CITY PLANNING COMMISSION

APPLICATION: Special Permit to provide 37 additional parking spaces in conjunction with an existing church located on 1.8+ acres in the Single Family, R-1 zone.

LOCATION: 1821 Meadowview Road

APPLC. NO. P-82-077

LANDSCAPE AND 50% PARKING AREA SHADING PLAN

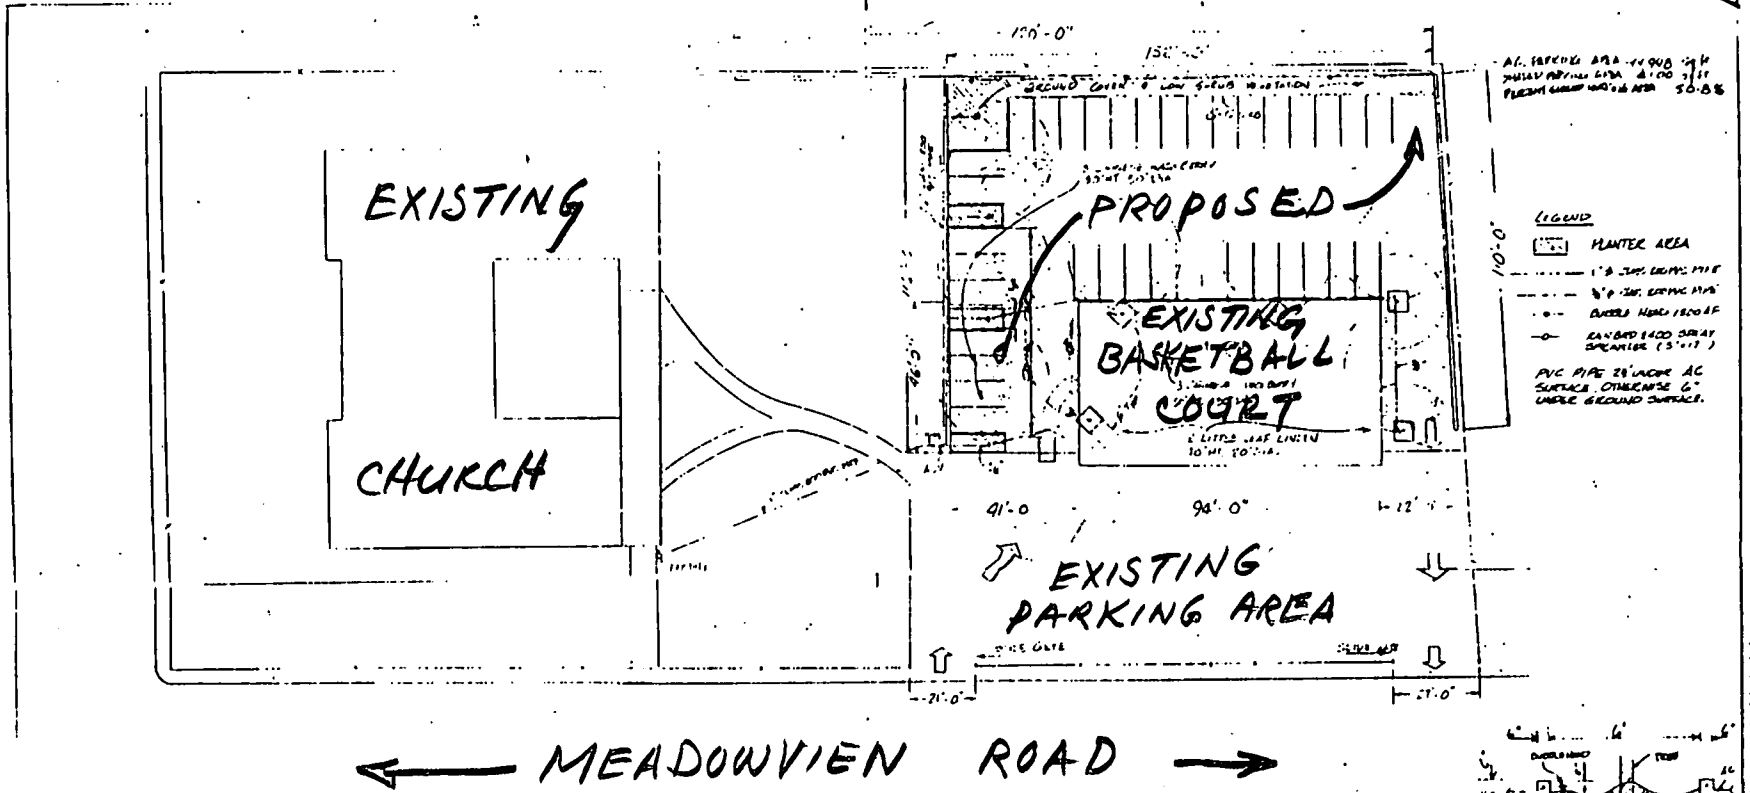
1. The applicant must submit a landscape plan indicating 50 percent shading of the new parking lot as required by the Energy Conservation Ordinance (Ordinance #4454) prior to the issuance of parking permit.
2. The site plan indicates an eight-foot wide planter strip located along the northerly property line. This is intended to provide a buffer to adjacent single family dwellings. Staff suggests that a four-foot landscaping strip be provided along the east property line to provide a buffer to adjacent dwellings.

In order to protect the planting area, staff suggests that a six-inch by six-inch raised concrete curb be provided around the planting areas.

3. The applicant has indicated that the solid six-foot high masonry wall will be constructed along the north and east property lines as required by the fence ordinance. This will provide a buffer and help reduce the noise transmitted from the automobile to the adjacent residences.
4. The proposed parking area is compatible with surrounding residential uses. Adequate buffering will be provided with landscaping and a masonry wall. Also, the additional parking spaces will relieve the on-street parking.
5. The site plan indicates the location of two tree wells located in the middle of a driveway that provide access to the proposed parking area. Staff suggests that the tree wells be relocated to allow adequate vehicular circulation.

1. Detailed landscape and irrigation plans shall be submitted for review and approval by staff. Landscaping shall include shrubs, ground cover, and a variety of five to 15 gallon trees and shrubs shall be utilized.
2. A four-foot wide planting strip shall be installed adjacent to the easterly property line.
3. The applicant shall submit a landscape plan indicating 50 percent shading of the parking lot as required by the Energy Conservation Ordinance (Ord. #4454) prior to issuance of building permits.
4. Bumper stops (six-inch by six-inch raised concrete curb) shall be placed on the north and west sides of the parking lot in order for automobiles to avoid hitting the planter area.
5. The two tree wells situated in the middle of the driveway that are located adjacent to the easterly property line shall be relocated to allow adequate vehicular circulation.
